NO-01-272
November 2, 2001

SUBJECT: Quality Assurance Program (QAP) Topical Report - Millstone Power Station
Revision 23, Change 2 (Document No. MP-02-OST-BAP01)

Summary of Changes to QAP Rev. 23 Incorporated as Change 02

**Organizational Relationship
of Functional Groups Having Quality
Functions for Millstone
Power Station**

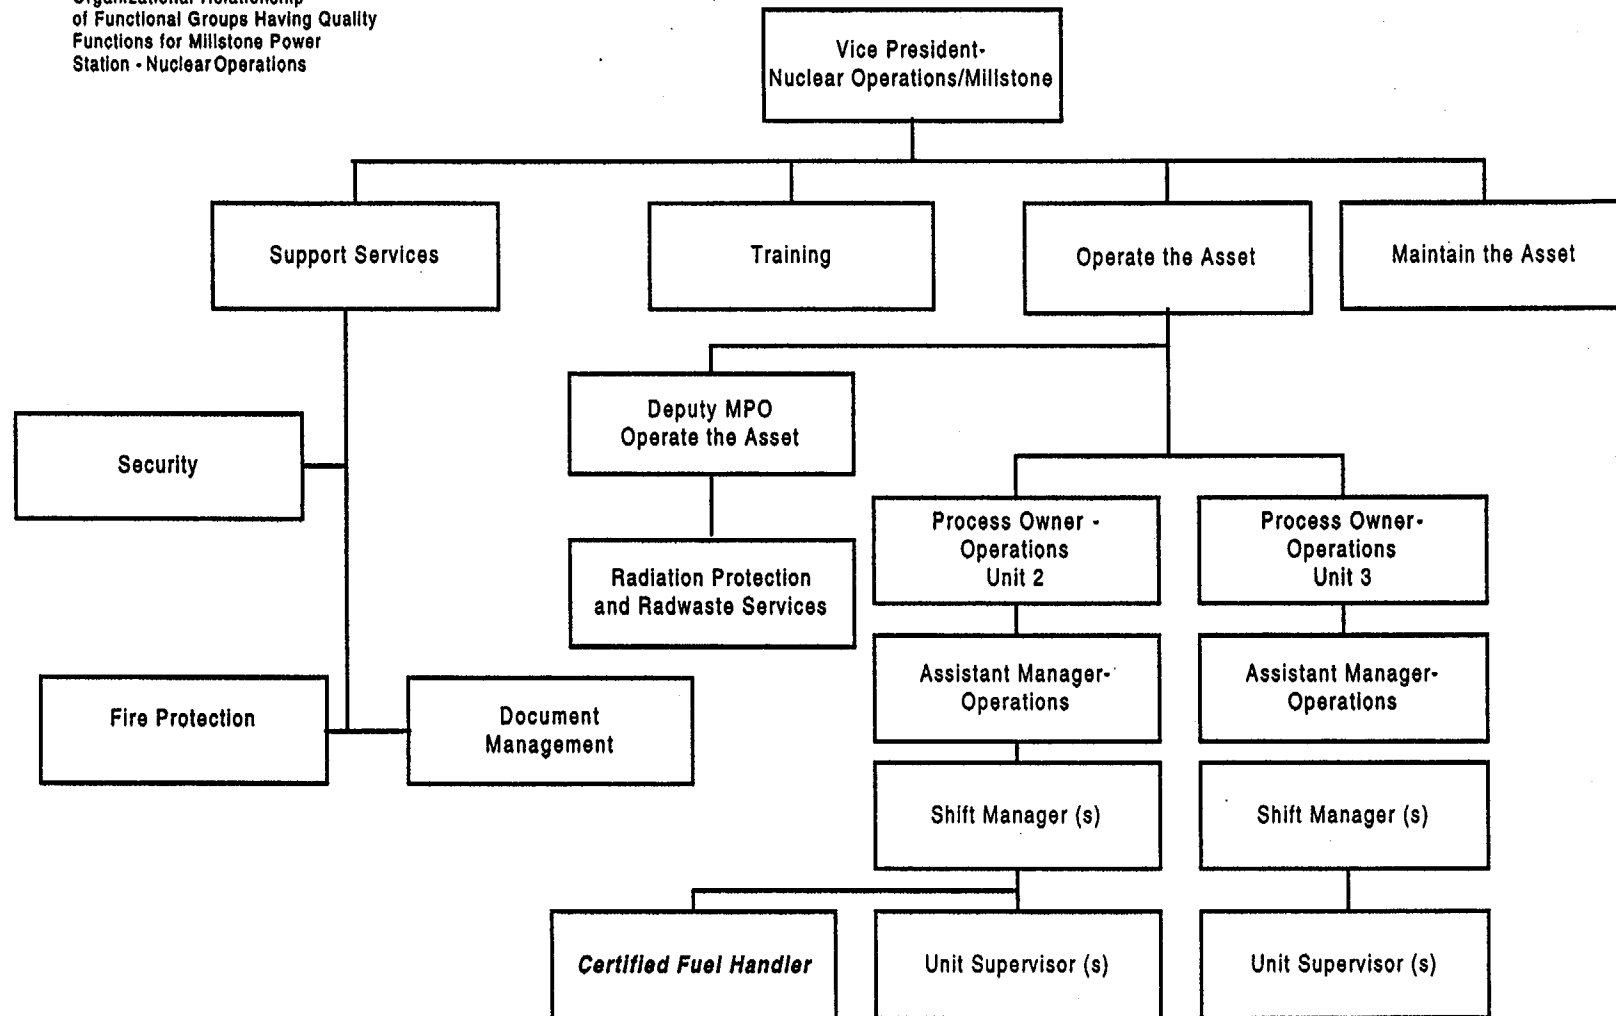
<u>Section</u>	<u>Summary Description of Changes</u>	<u>Reference</u>
Section 1.0	Modified Sections 1.3.6, 1.3.7 and Figure 1.1 to transfer the responsibility for Unit 1 activities regarding the Spent Fuel Pool Island and auxiliary systems to Unit 2 Operations.	Request 01-11
Appendix G	Assigns Unit 1 Technical Specifications regarding Shift Manager to Unit 2 Shift Manager	Request 01-11

Unit 2 Operations is responsible for operations regarding the Unit 1 Spent Fuel Pool Island and auxiliary systems. A Certified Fuel Handler augments the Unit 2 Operations staff to meet Unit operations responsibilities. The transfer of Unit 1 Operations' responsibility to Unit 2 Operations will not impact the capability of Unit 2 Operators to perform their duties, including day-to-day functions and accident and transient mitigation.
